MANDATORY SERVICE BULLETIN NO. DAC1-34-10 REV. 0

Type: DA 20-C1

S/N: C0699, C0700, and C0701

GTx345 and TAS605 audio lines.

Figure 1. Reference for steps 4 to 6.

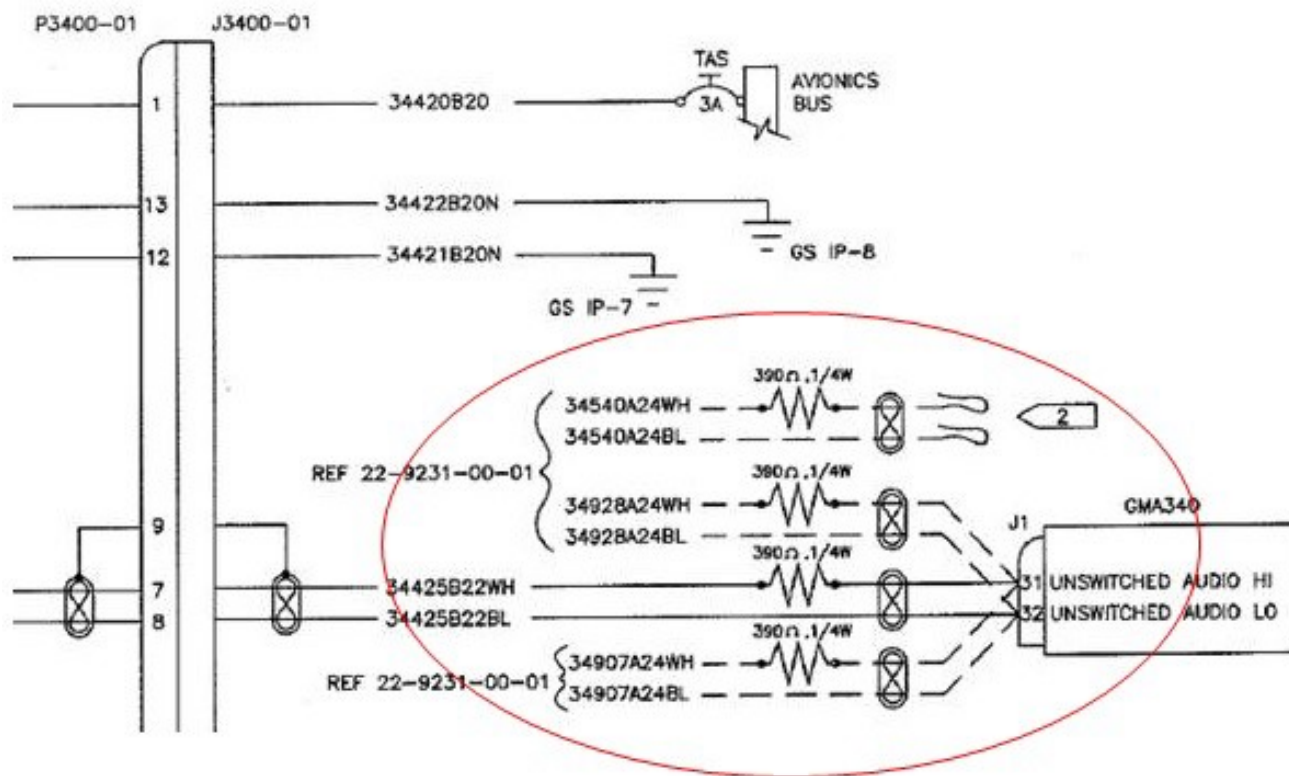
1. Pull the battery circuit breaker located on the right side of the instrument panel.
2. Disconnect the aircraft battery as per AMM Chapter 24-31-00.
3. Remove the instrument panel cover as per AMM Chapter 25-10-00.
4. Cut all the tie wraps along the top of the avionic radio rack behind the GMA340 audio panel.
5. Pull out all four resistors and associated splices from the wire bundle. See Figure 1, below.
6. Locate wire 34425B22 and remove splice between the white wire and the resistor. Take care to keep the resistor leg as long as possible.

Figure 2. Reference for step 7 onwards.

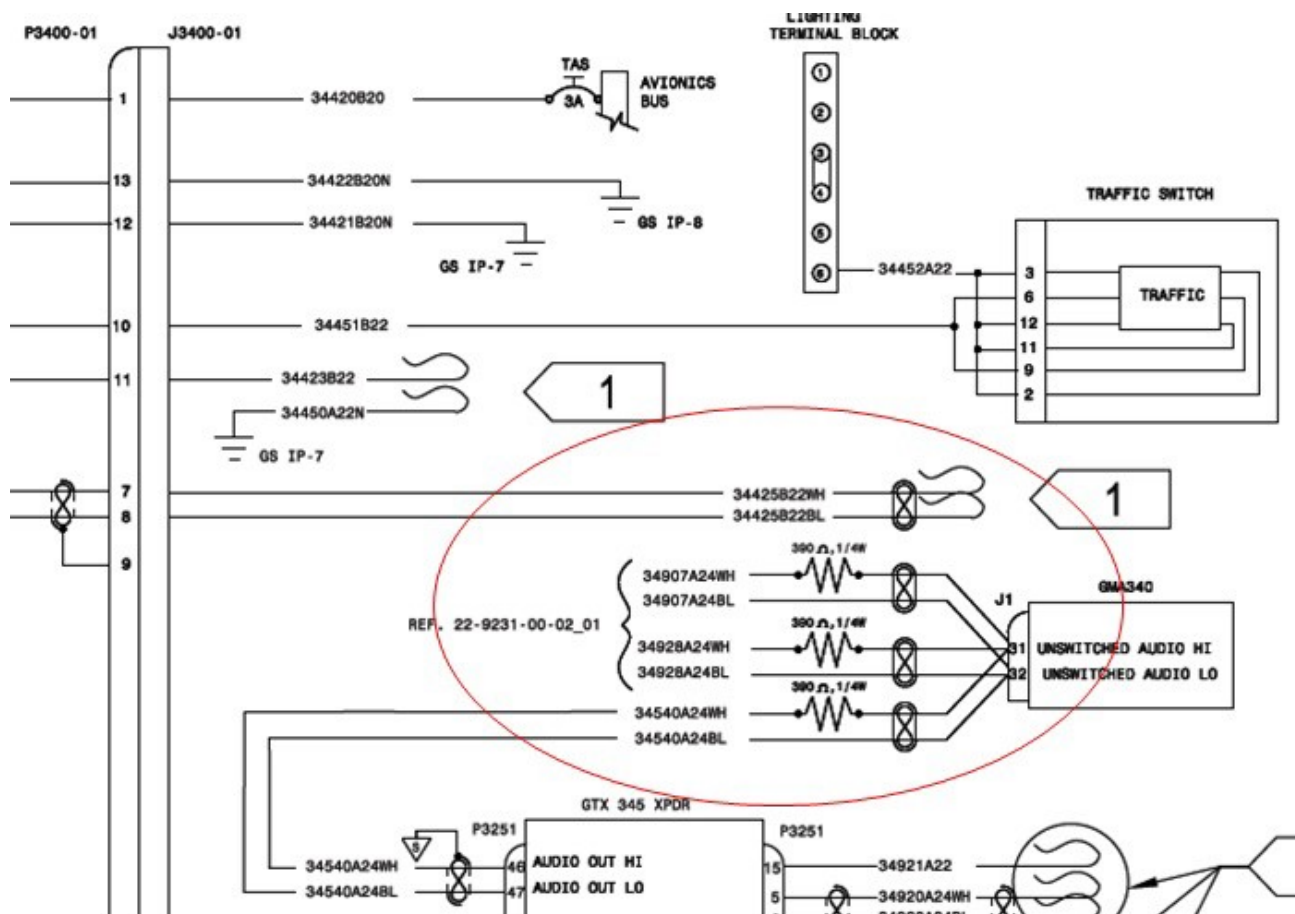
7. Cap and stow the 34425B22 white wire. See Figure 2, below.

8. Locate wire 34540A24 and remove the splice between the white wire and the resistor. Take care to keep as much of the white wire as possible. Discard the resistor and jumper wire that is capped and stowed in the GMA340 J1 connector backshell (also refer to Figure 1).
9. Splice the white wire of 34540A24 to the resistor that was previously connected to wire 34425B22.
10. Neatly tie wrap the avionic wire bundle behind the GMA340 audio panel.
11. Inspect the work performed and check for FOD.
12. Connect the aircraft battery as per AMM Chapter 24-31-00.
